TELEVISION TECHNICAL BULLETIN

<u>MODELS</u>	51CS03H	59CS03H	66CS03H
	51CS05H	59CS05H

Location of wire link on component side of PWB

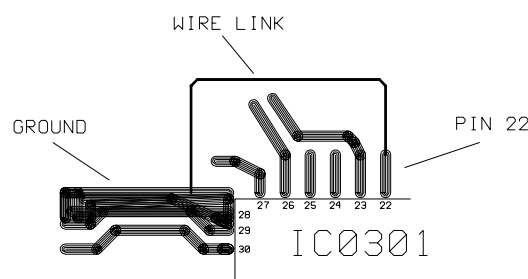
SYMPTOM When used in a hot environment a bleeping sound may be heard from the speakers or there is intermittent sound loss.

CAUSE Pin 22 of IC301 floating.

ACTION Insert wire link between pin 22 of IC301 and ground as indicated in the diagram below.

To make the insertion of this link easier remove X301, fit wire, then replace X301.
